# Questions on 3.1 Botanic Garden ki Paekākā to City bike and bus improvements - traffic resolution approval

Pūroro Āmua | Planning and Environment Committee 11  
August 2022

Bowen St proposed parking arrangement changes: (Compare with Fig 3.1 of current parking arrangements in PMP)

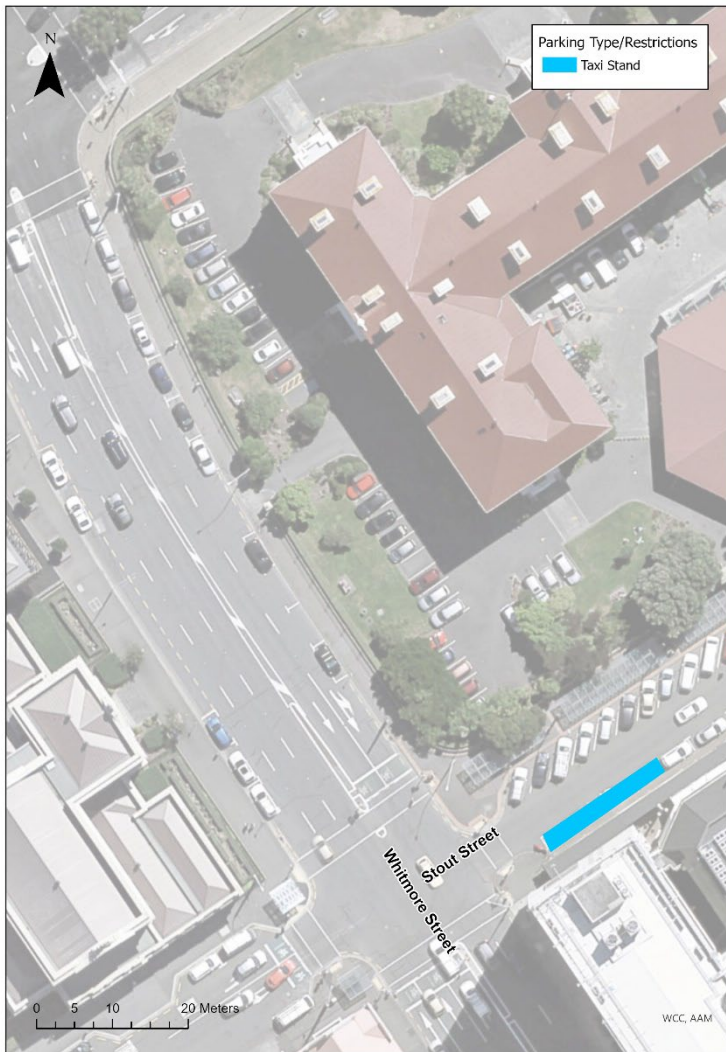
Can you please update figures 2.1, 3.1 and 4.2 from the Parking Management Plan (PMP) with the parking arrangements proposed in the TR?

Tinakori Road proposed parking arrangement changes: (Compare with Fig 2.1 of current parking arrangements in PMP)

Whitmore St proposed parking arrangement changes: (Compare with Fig 4.2 of current parking arrangements in PMP)

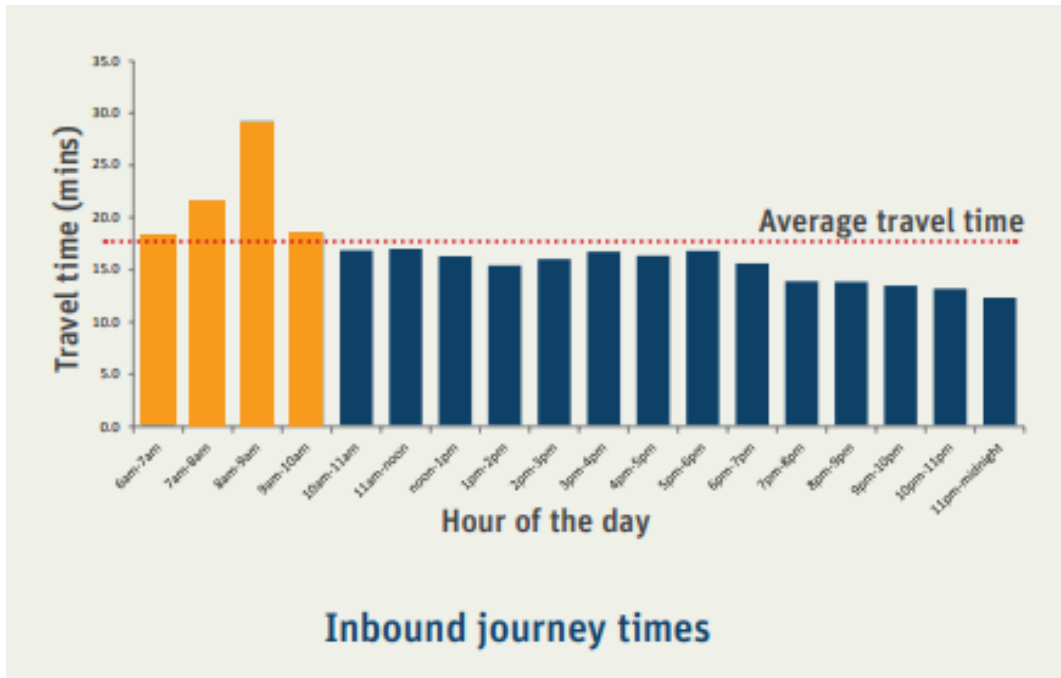
How many P120 parking spaces are situated in the downhill bus/bike lane on Tinakori Rd? Can you confirm there are only P120 spaces in the bus/bike lane?

There are 10 P120 parks and 2 P10 available for parking between 9am-8pm Monday – Friday and 8am-8pm Saturday – Sunday. The bus / bike clearway will operate between 7am-9am Monday – Friday.
